PUBLIC HEARING/WORKING SESSION MEMORANDUM

PETITION #125-21 740 Beacon Street

Re: Transportation Peer Review – Proposed Marijuana Establishment & Administrative Offices

RE: Response to Comments

Proposed Internal Site Improvements

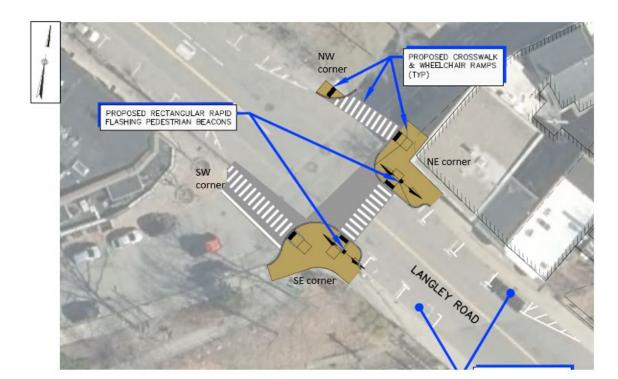
The Committee discussed creating a sidewalk rather than a path along the eastern boundary of the passageway from Union Street. Such a sidewalk would be challenging because the petitioner does not own the passageway (it is shared between 5 properties) and the sidewalk would reduce the width of the drive aisle and would require zoning relief in the form of a joint petition from all fee owners of the passageway.

Intersection of Beacon Street/Union Street/Driveway showing gore markings and lack of pedestrian connectivity on Beacon Street

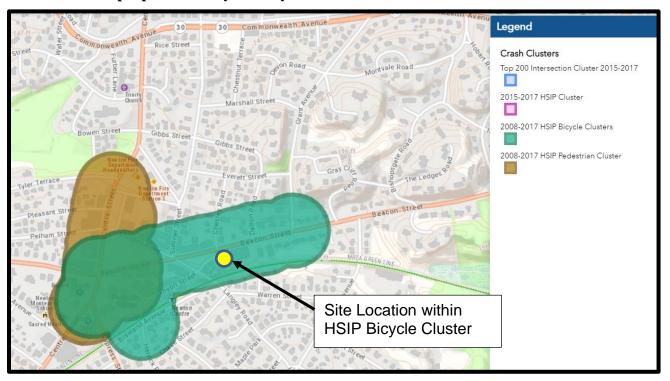
A sidewalk is provided along the south side of Beacon Street, but ends without any connection to other pedestrian facilities (see below). BSC recommends that a crosswalk be provided across Union Street in conjunction with intersection improvements to provide better pedestrian connectivity.

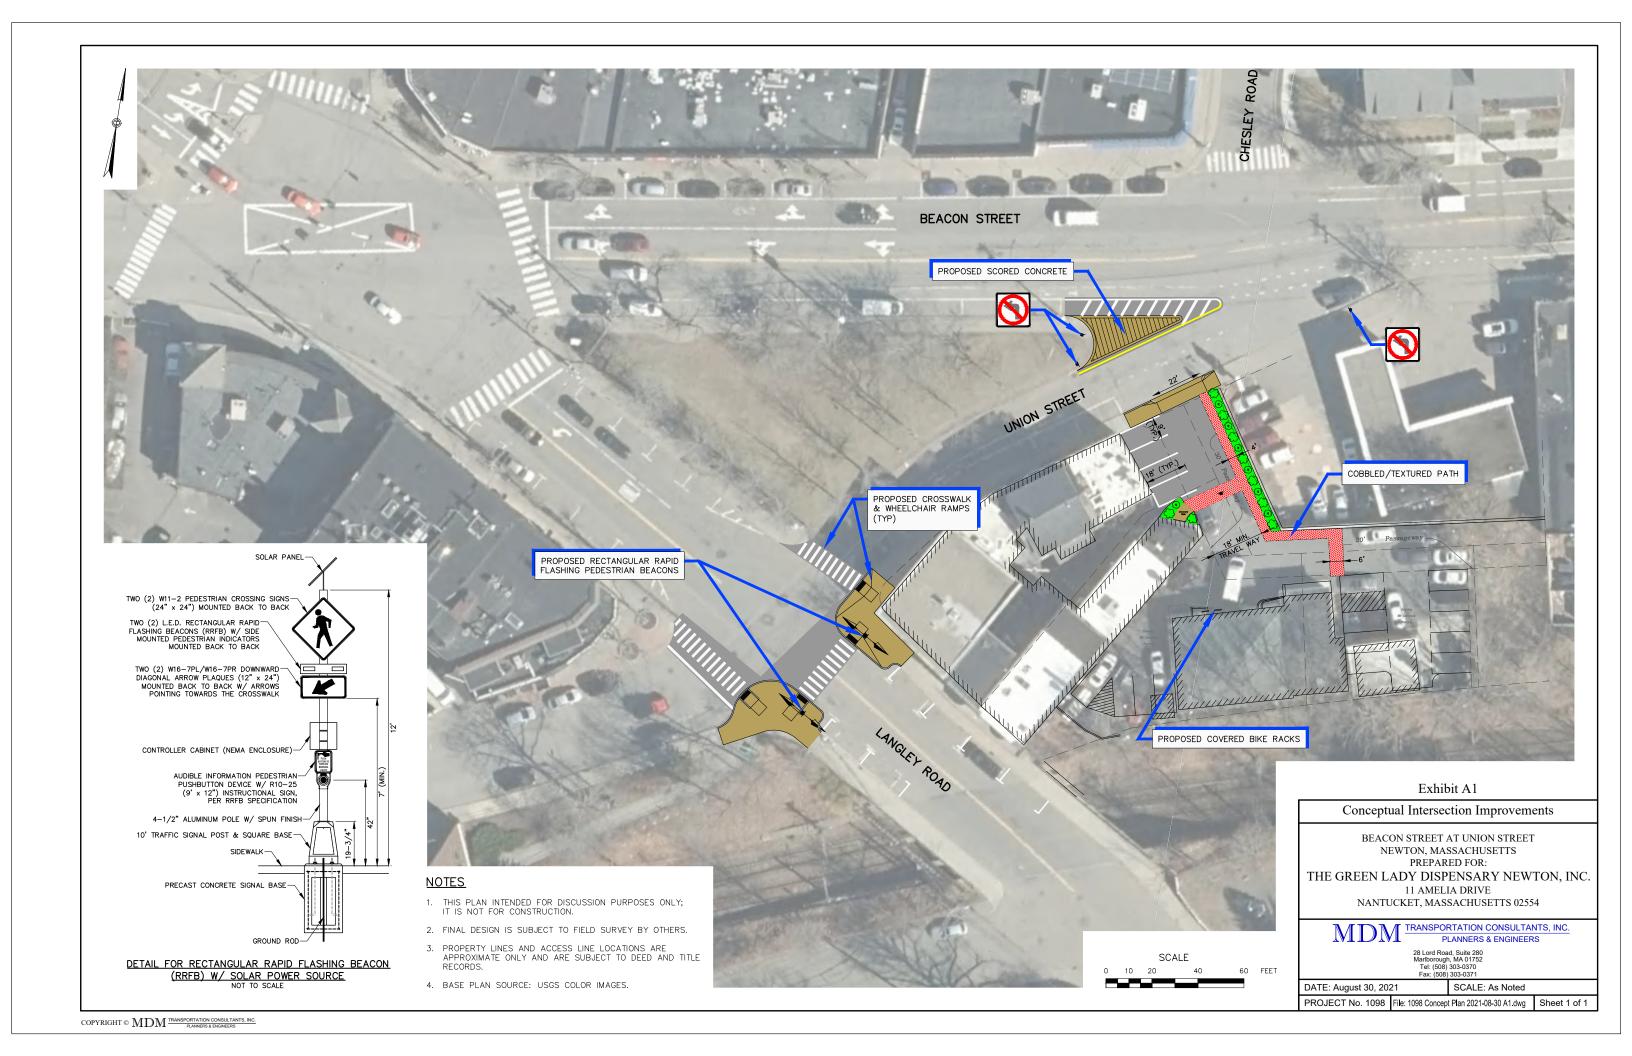
A sidewalk is provided along the south side of Beacon Street but ends without any connection to other pedestrian facilities (see below). BSC recommends that the Applicant review the feasibility of installing a crosswalk from Beacon Street to Union Street, west of the site driveway to provide better pedestrian connectivity. Should the installation of a crosswalk at this location be feasible, we recommend that the Applicant install the necessary curb ramps, sidewalk extension on Beacon Street, and crosswalk."

Response: The Applicant's programming does not rely on on-street parking for customers and does not have the authority to remove public on-street parking. The City at its option can chose to remove the on-street parking space near the Beacon Street intersection with Union Street independent of the proposed development.

Prior consultation with the City's DPW indicates a preference to improve the Langley Road intersection as a priority in this area. Accordingly, the Applicant has identified conceptual improvements for the Langley Road intersection at Union Street that serve to advance the City's near-term goal to enhance the pedestrian environment along this corridor. These improvements are shown conceptually in **Exhibit A1** and include curb extensions and pedestrian beacons. The Applicant defers to the City on whether these pedestrian improvements take precedence over other potential area improvements such as Union Street at Beacon Street and further commits to designing and constructing these improvements as shown in **Exhibit A1** in support of the primary pedestrian desire line to/from the project.

The Applicant has also developed an alternative conceptual design plan (see attached Exhibit A2) to enhance the sidewalk connection between Beacon Street and the Site; this improvement may be augmented by a potential curb extension along Union Street to reinforce the left-turn restriction from Beacon Street onto Union Street. MDM notes that traffic operations at the Beacon Street/Union Street intersection are generally unconstrained (LOS C or better even assuming that left-turn movements occur from Union Street to Beacon Street) and the intersection is not a high crash location; as such the City may wish to revisit the left-turn restriction on the Union Street approach to Beacon Street. If the City deems improvements identified under Exhibit A2 as preferred over those at the Langley Road and Union Street intersection, the Applicant will at the City's direction design and implement improvements shown in Exhibit A2.
